# **Third Addendum to the Supplemental Sewer Investigation Work Plan**

Ex-Eaton Site  
34-40 Clinton Street  
Batavia, New York  
Site No. C819022

# NEW YORK STATE DEPARTMENT OF ENVIRONMENTAL CONSERVATION

**Re: Ex-Eaton Site (#C819022)  
22-40 Clinton Street, Batavia, Genesee County  
Third Addendum to the Supplemental Sewer Investigation Work Plan,  
September 12, 2019**

**FIGURE 1.1**

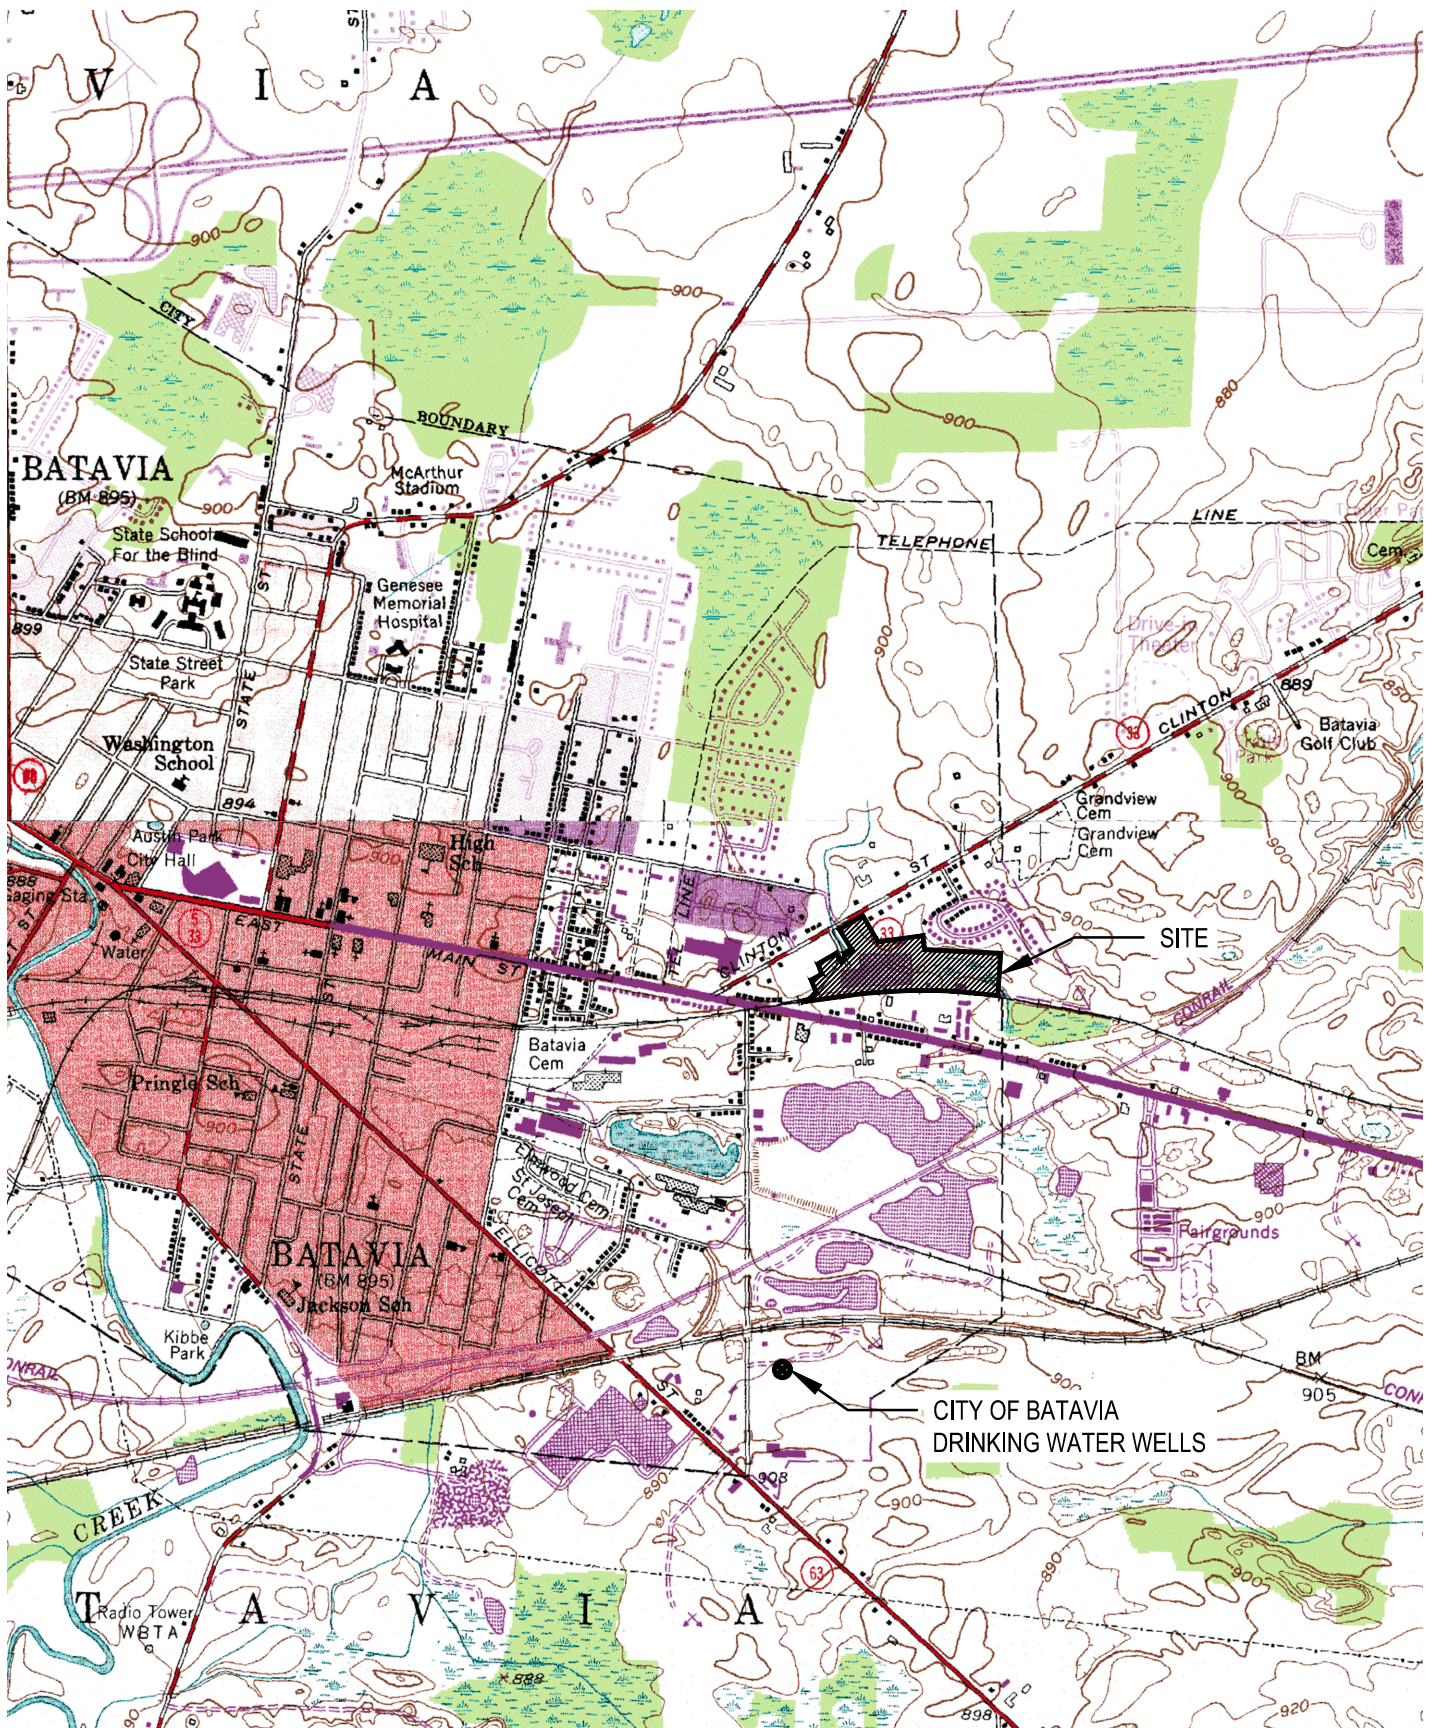
5. Section 5, the Master Schedule received on October 31, 2019 will be adhered to as the project schedule. The schedule is enforceable under the Brownfield Cleanup Agreement and is not "tentative". Extensions to the approved schedule must be requested in writing and approved by NYSDEC.
6. Figure 1.1, the location of the "City of Batavia Drinking Water Well" is changed to "Wells".
